Southern Nuclear Operating Company
Vogtle Electric Generating Plant Units 3 and 4 Combined License Application
Second Supplemental Response to Request for Additional Information Letter No. 18

Second Supplemental Response to RAI 03.07.02-1

FSAR Section 3.7, Seismic Design

Revised FSAR Appendix 3GG

Figure 21. Horizontal X Response Spectra at ASB Corner of Fuel Building Roof at Shield Building (El. 179.19 ft, Node 11111)

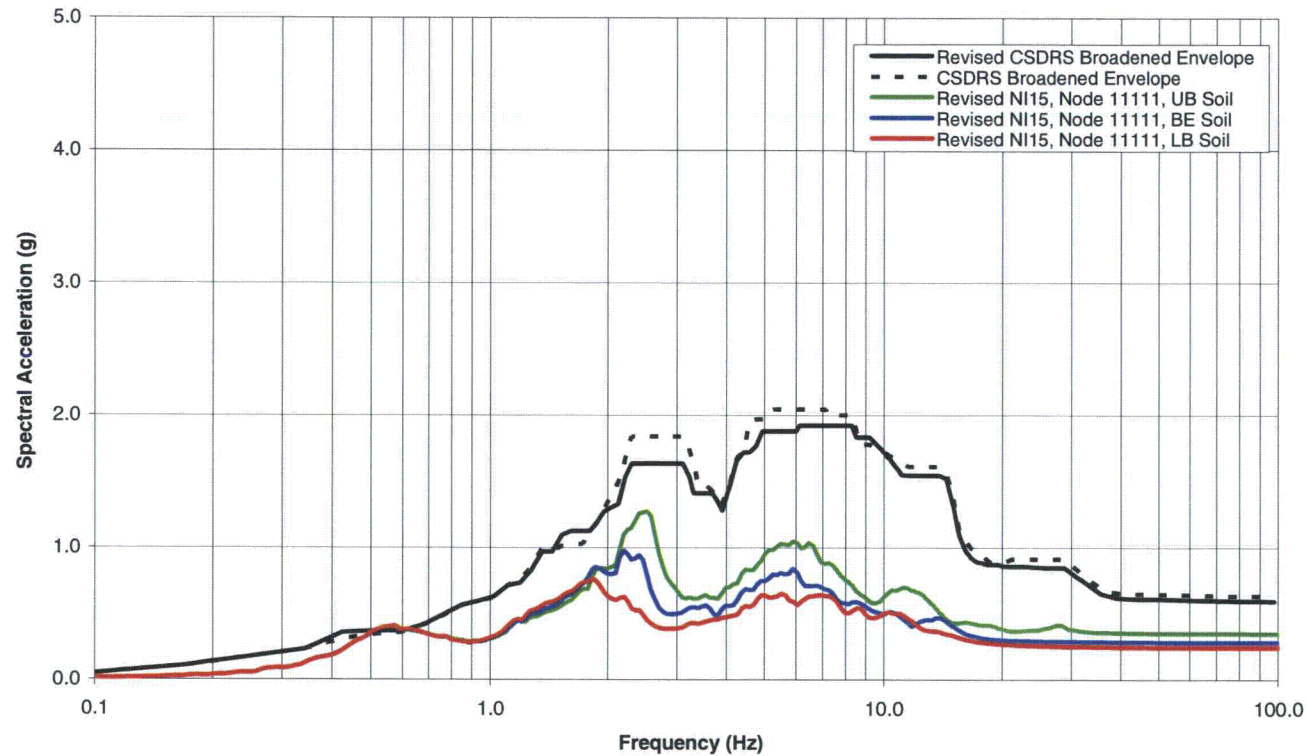
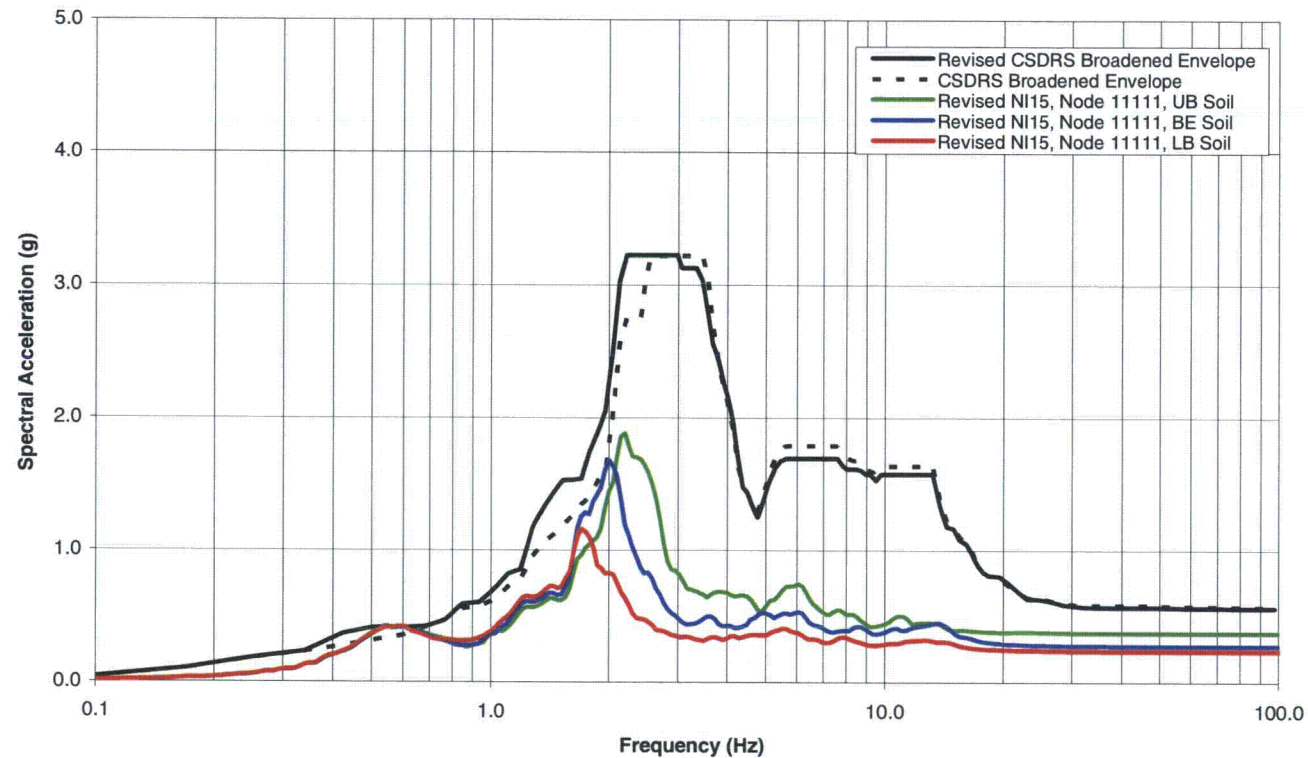
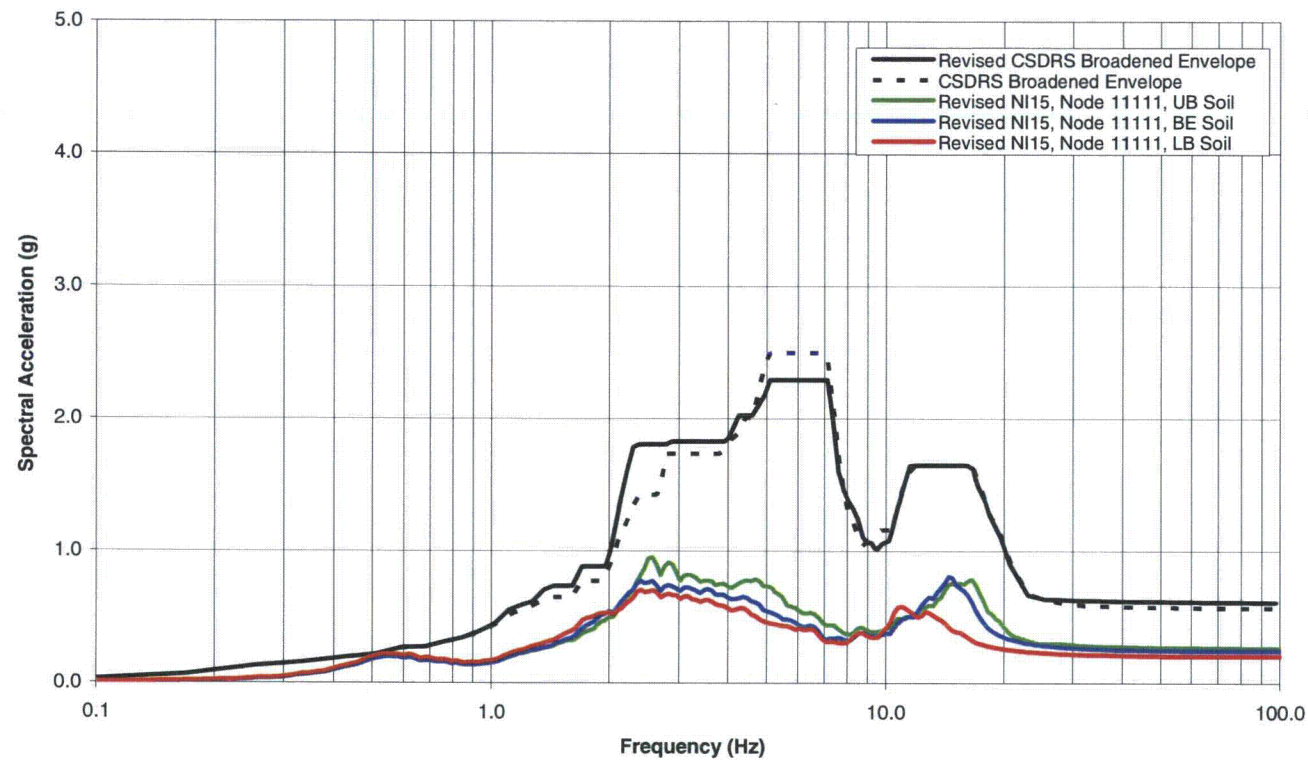
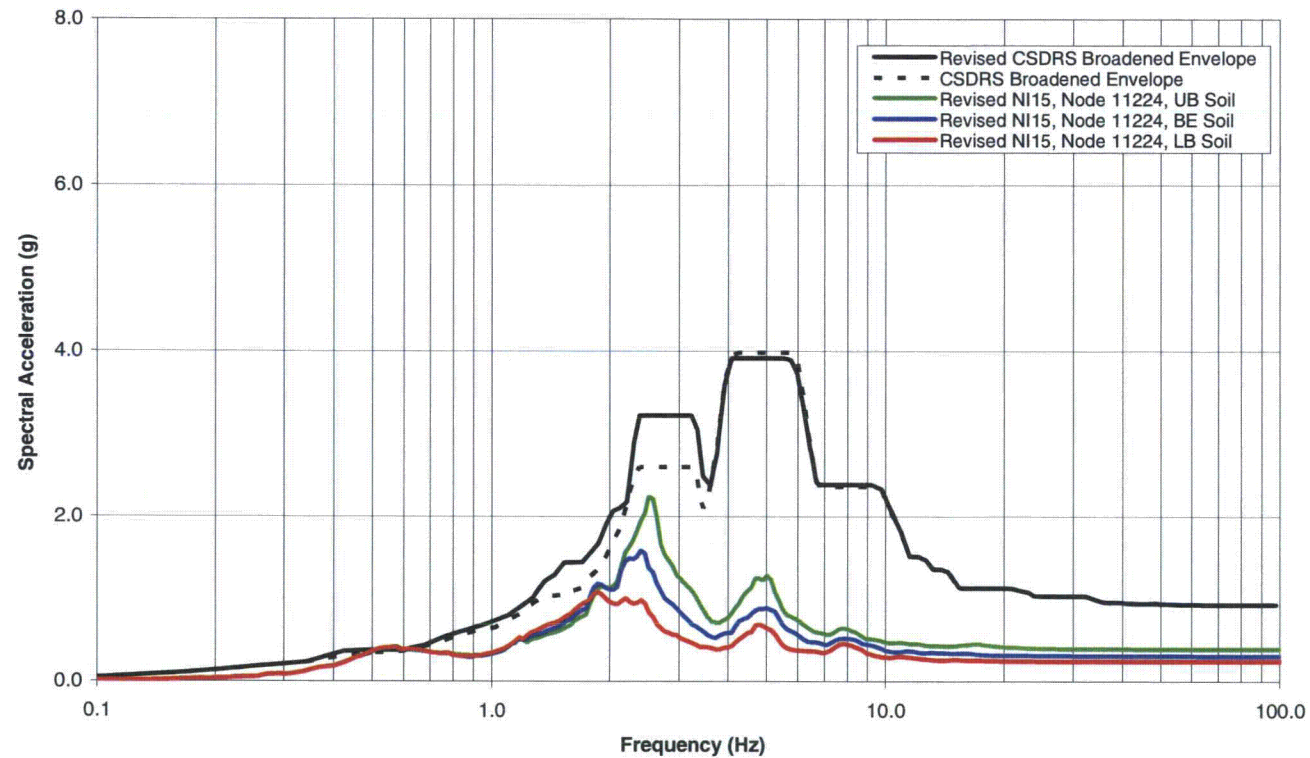
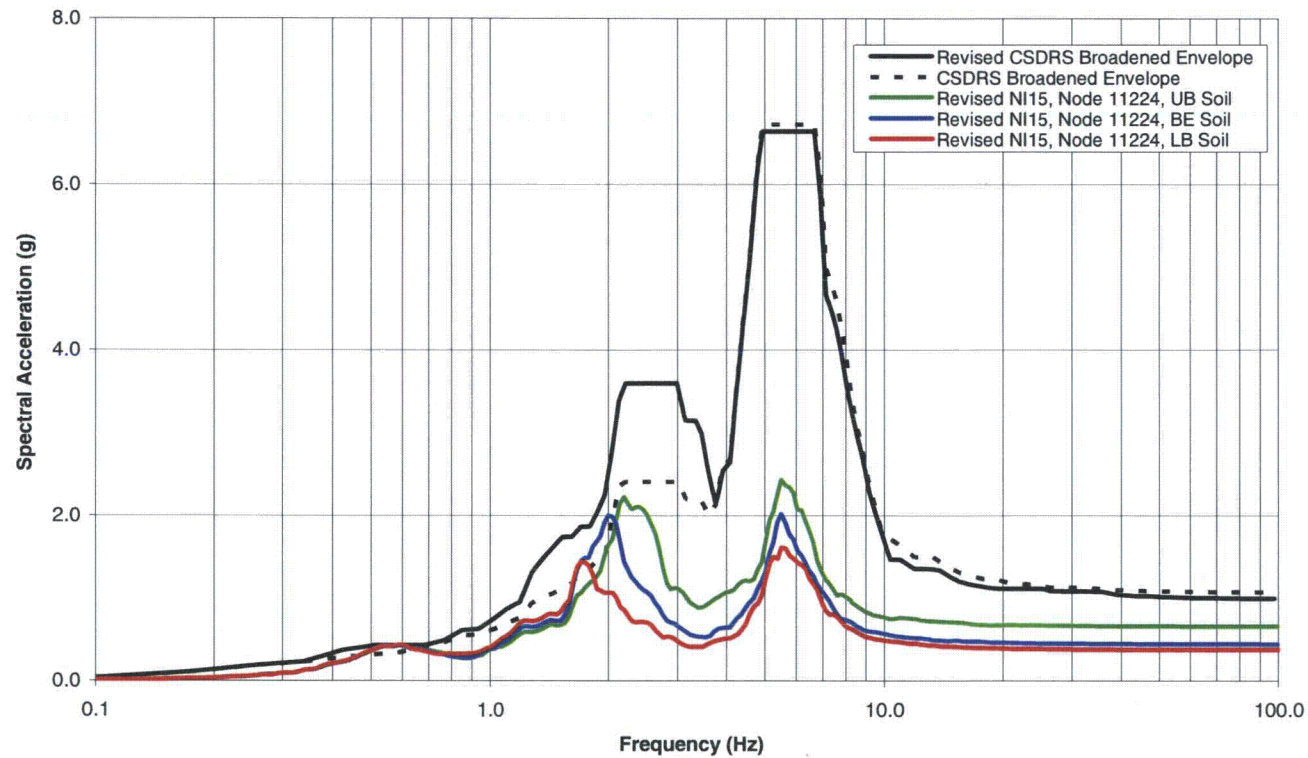
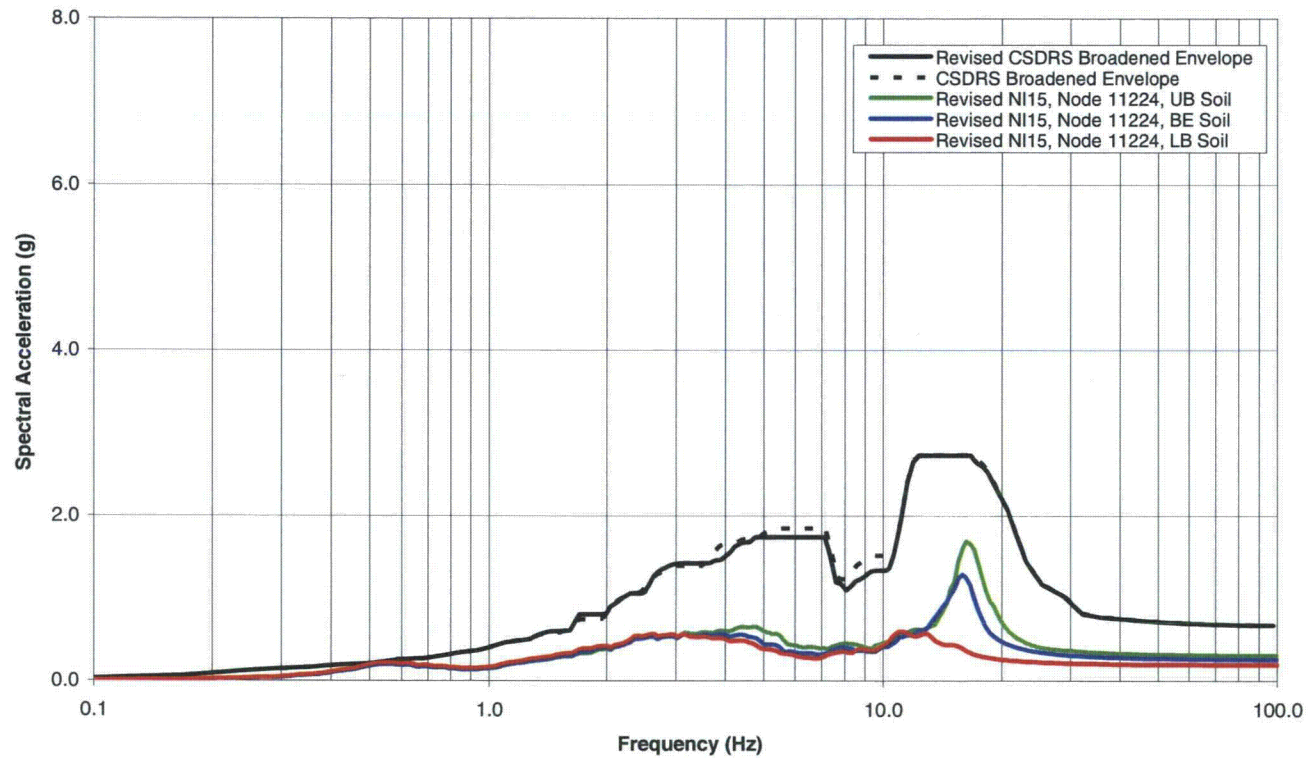
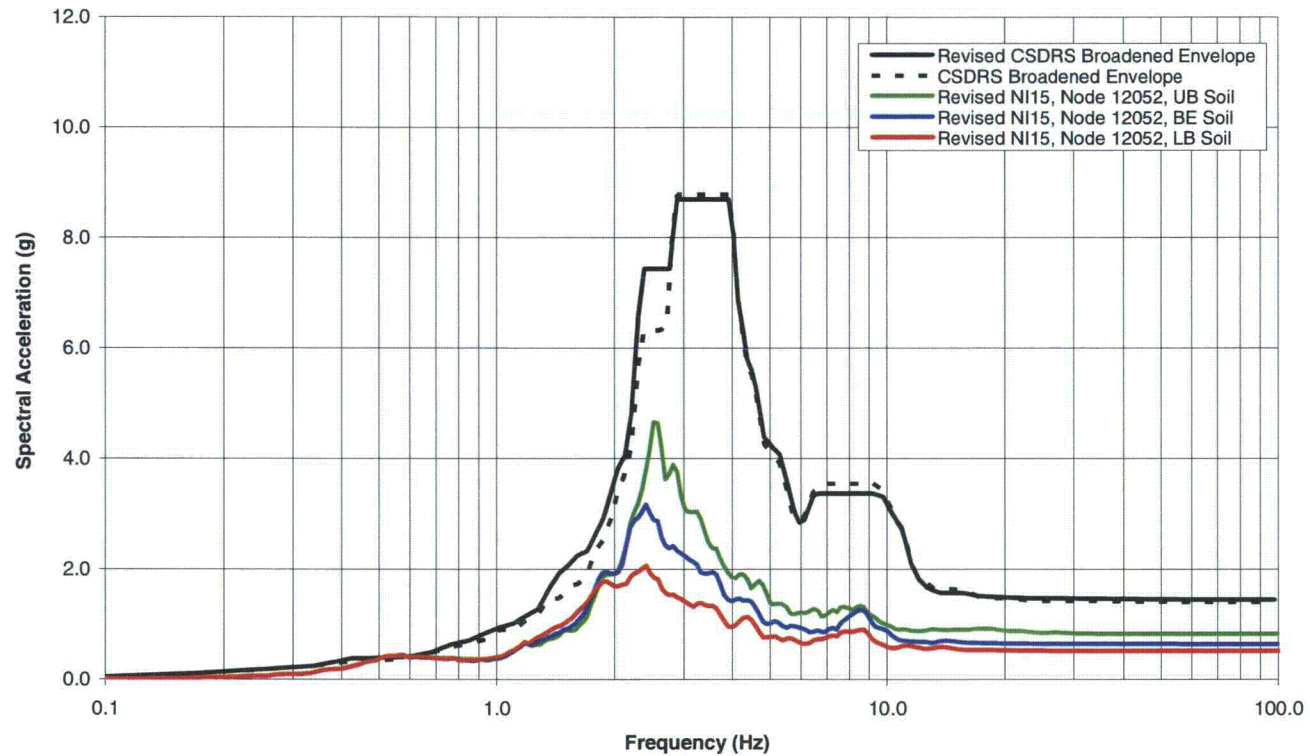
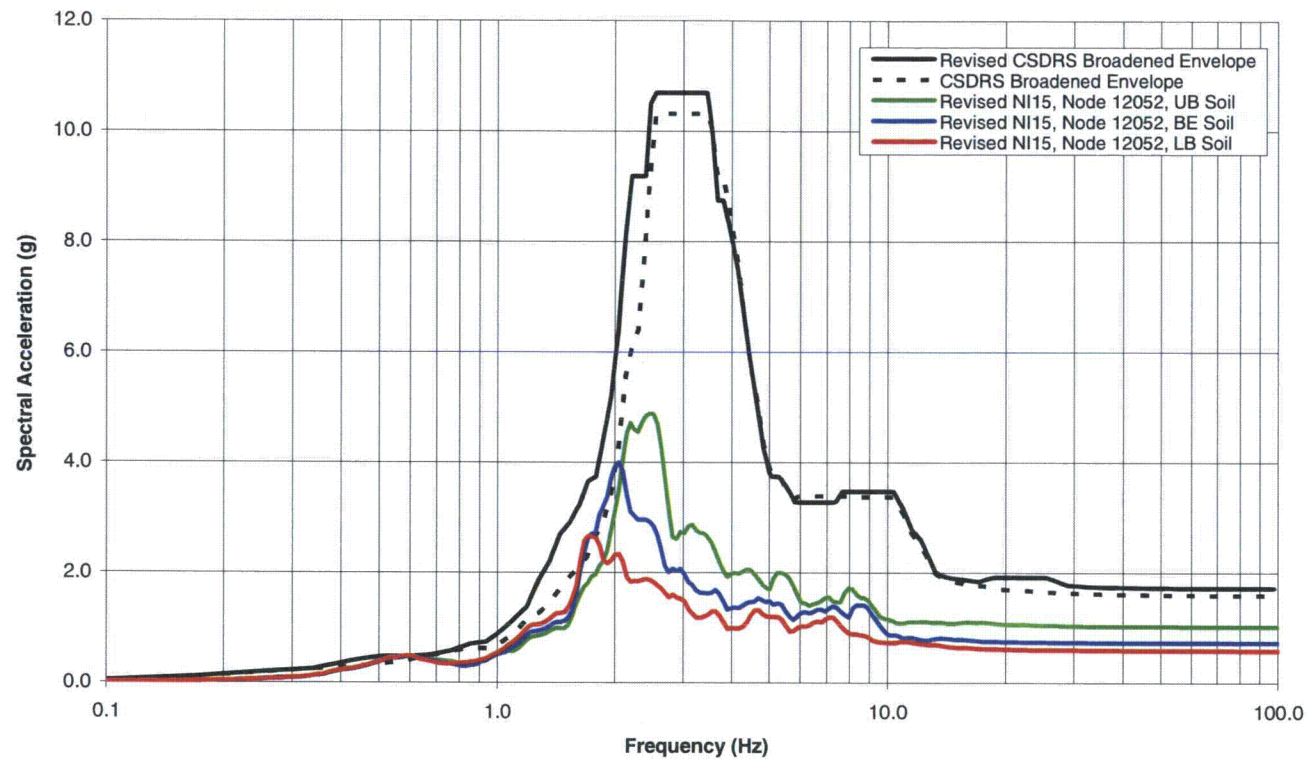
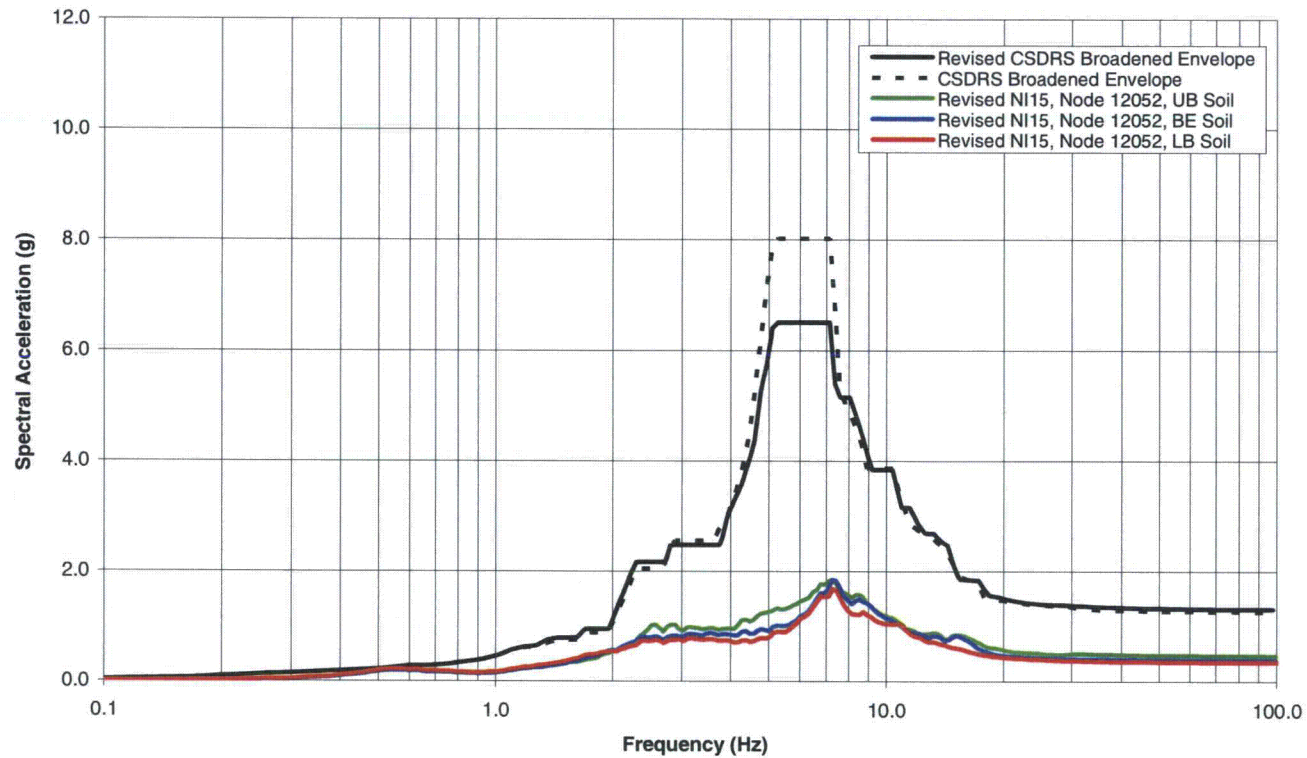
Please justify the adequacy of the 2D SASSI response analysis in light of the magnitude of the vertical response in the 3D SASSI detailed response analysis models.

Enclosure 2 to this letter provides a proposed FSAR Appendix 3GG revision, which shows the 5% damped Vogtle ISRS compared to the revised AP1000 CSDRS broadened envelope ISRS at the six key locations. For a point of reference, the comparisons also include the original AP1000 CSDRS broadened envelope ISRS to aid in understanding the differences in the revised ISRS comparisons. This proposed FSAR revision will be incorporated into a future version of the VEGP Units 3 and 4 COL Application.

1. The revised Vogtle NI15 SASSI ISRS are almost identical to the original Vogtle NI15 SASSI ISRS provided in the supplemental response to RAI 3.7.2-1, especially in the lower frequency range below 10 Hz.
2. The revised AP1000 CSDRS broadened envelope ISRS at the six key locations (Ref. 1) has changed such that above 1 Hz there are now no exceedances of these AP1000 CSDRS broadened envelope ISRS by the revised Vogtle NI15 SASSI ISRS. Below 1 Hz, there is exceedance near 0.55 Hz as before; but now the amount of the exceedance is much less and primarily only in the X direction.
3. The exceedances near 0.55 Hz have been addressed previously where they were shown to have no impact on the AP1000 design.

As shown in these figures, the “design envelope” exceeds the site specific response motions basically over the entire range of frequencies and by a large margin. This margin is particularly large at the zero period acceleration level indicating a large margin for seismic member forces. At a very limited frequency range, small exceedances beyond the design envelopes are observed. The exceedance at about 0.55 Hz is consistent with the previous two-dimensional SSI results and has no design consequence since there are no structural members at this frequency.
